BURNHAM ABBEY CONSERVATION GROUP

WRITTEN REPRESENTATION

HIGHWAYS ENGLAND'S RESPONSE

HUNTERCOMBE Conservation Area

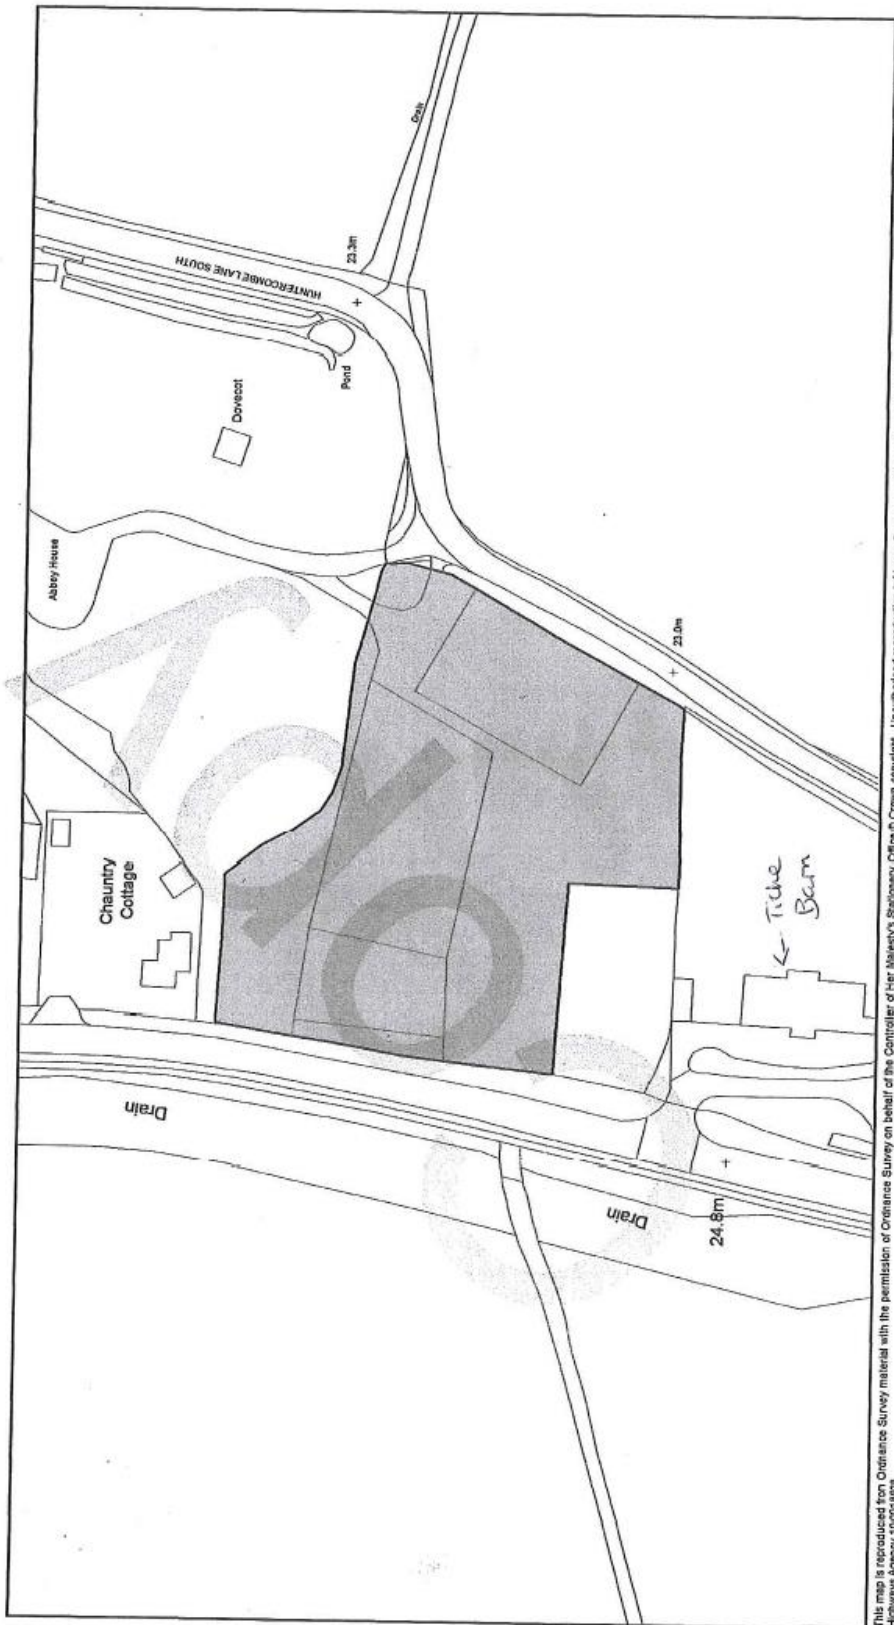
- 4.1 *Firstly, it is important to stress that buildings and land to the east and north east on the north side of the proposed widened Lake End Road bridge belong to Burnham and Huntercombe Conservation areas, V51 and V52 (map?) designated 1977. Quote p 1 (3) "It is an area of special architectural or historic interest whose character or appearance it is desirable to preserve or enhance" therefore it is desirable that as little as possible should be done to interfere with this area during the time the bridge is being built.*

5.1.2 The southern boundary of the Huntercombe Conservation Area follows the highway boundary at the junction of Lake End Road and Huntercombe Lane South. Plot 20-14 comprises “*Public road, footway and verges (Lake End Road, B3026) and public road and verges (Huntercombe Lane South)*” as described in the Book of Reference (Application Document Reference 4-3) and shown on the Land Plans Sheet 20 (Application Document Reference 2-2). It is not proposed to acquire any land within the Huntercombe Conservation Area permanently or temporarily.

M4 Junction 3 to 12 Smart Motorway
Land ownership parcel number: 19201
Summary of interest: Hardstanding and garden (Huntercombe Lane South)

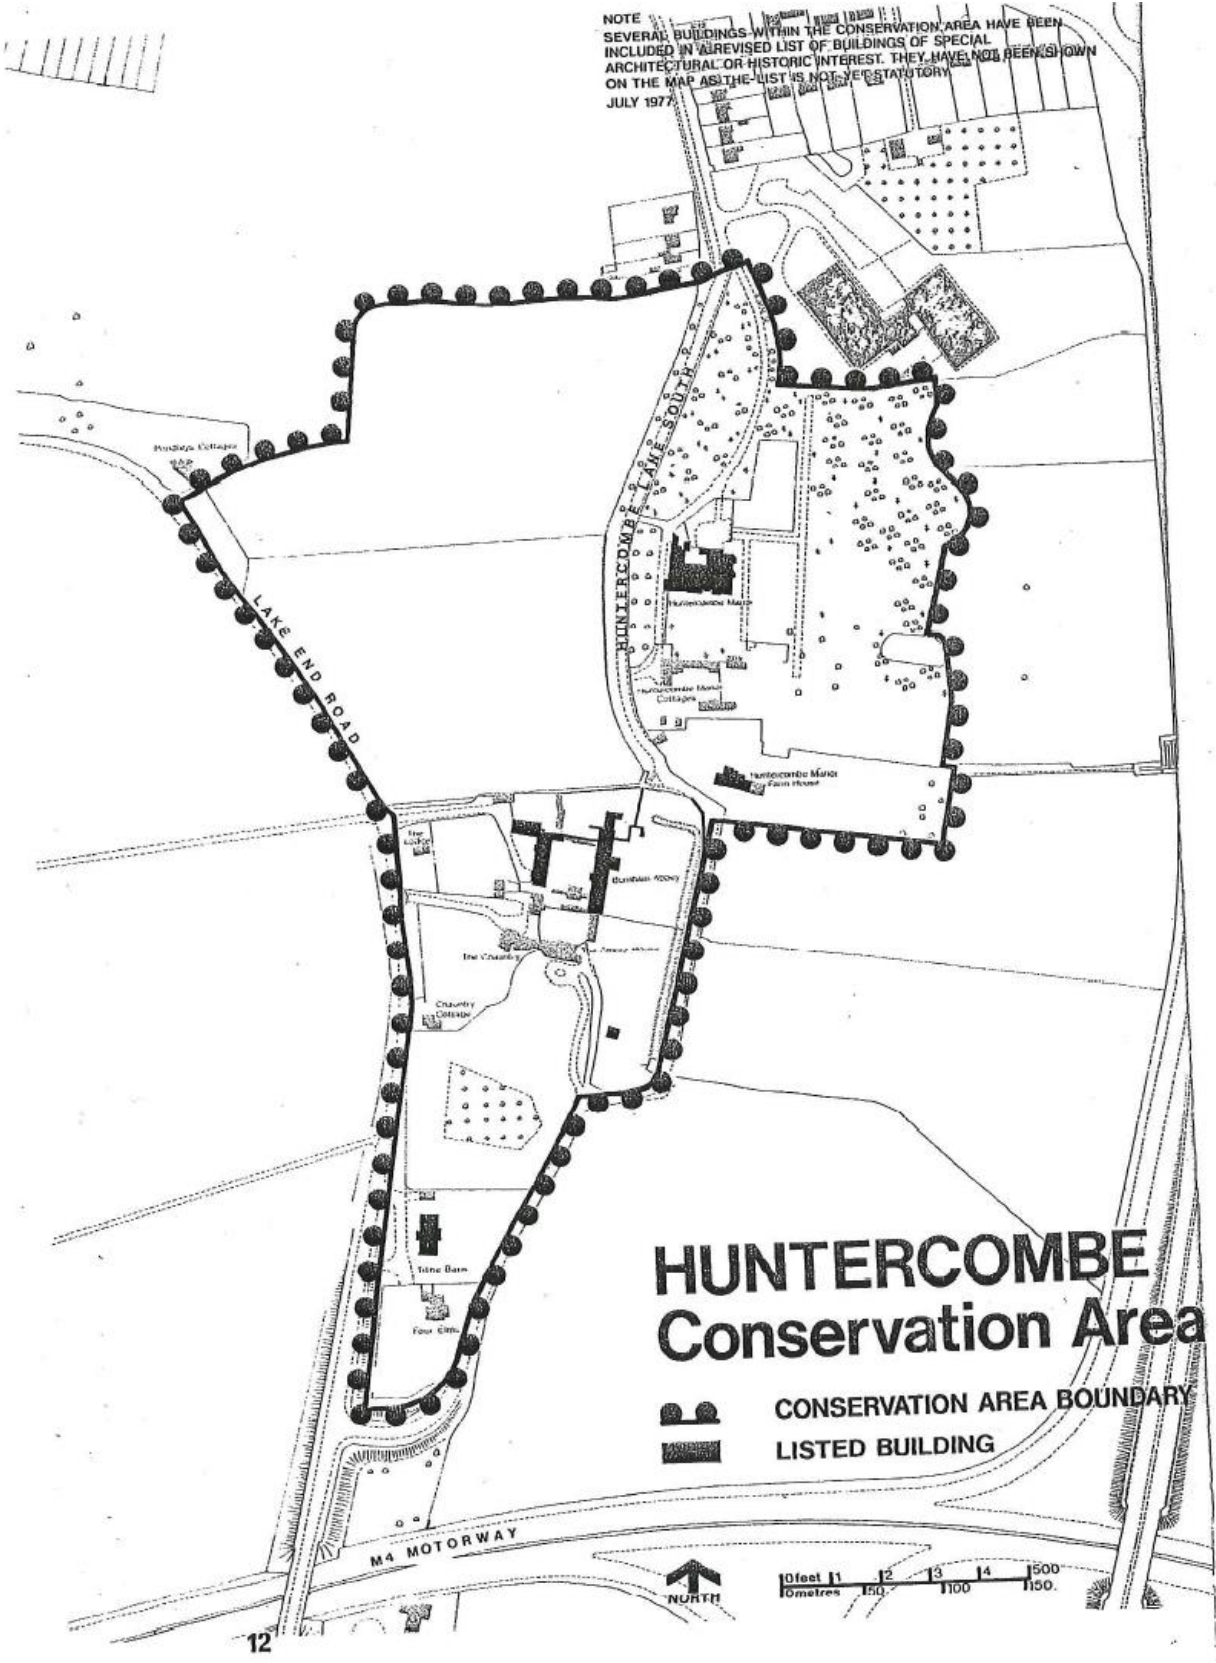
- 4.1.1 Highways England notes the concern raised by Burnham Abbey Conservation Group and outlines detailed responses to alleviate all issues raised in the written representation below.
- 4.2 *The owners of Abbey House received notification from the Planning Inspectorate that there was a possible interest in 2 acres of land in the garden of Abbey House, (Ref. 19201), being the subject of a compulsory acquisition order. However, no further official communication*

5.2 *The land that was of interest in the Abbey House garden is used for the keeping of ponies. These ponies are for the use of disabled children, and a Charity has been set up for these children. The area you described as "hard standing" is in fact an Olympic sized horse Manege. In the surrounding areas there are far more appropriate sites such as flat farmland with safe access, the Animal Sanctuary site which will shortly become vacant, and, adjacent to that, a commercial industrial 'yard' that processes skip materials. As such, this site is already suitable for heavy vehicles.*

4.2.1 Highways England confirms that the owners of Abbey House were contacted in April 2014 regarding a request for land ownership information as part of the land referencing process. The information provided was used to inform and develop the design of the M4 Junctions 3 to 12 smart motorway scheme (the "Scheme"), resulting in the identification of no requirement for compulsory acquisition powers over this piece of land (Ref. 19201). However, the owners of Abbey House were consulted in relation to the Scheme pre-application, under section 47 of the Planning Act 2008.

4.2.2 In order to clarify the compulsory acquisition sought in this area, the only relevant plots in this vicinity over which powers of compulsory acquisition are being sought are the following, as shown on sheet 20 of the Land Plans (Application Document Reference 2-2), none of which impact on the land ownership of Abbey House:

5.1.4 As stated in the response to paragraph 4.2 above, the land at Abbey House (Ref. 19201) is not required by the Scheme.

5.2.1 As stated in the response to paragraph 4.2 above, the land at Abbey House (Ref. 19201) is not required by the Scheme.
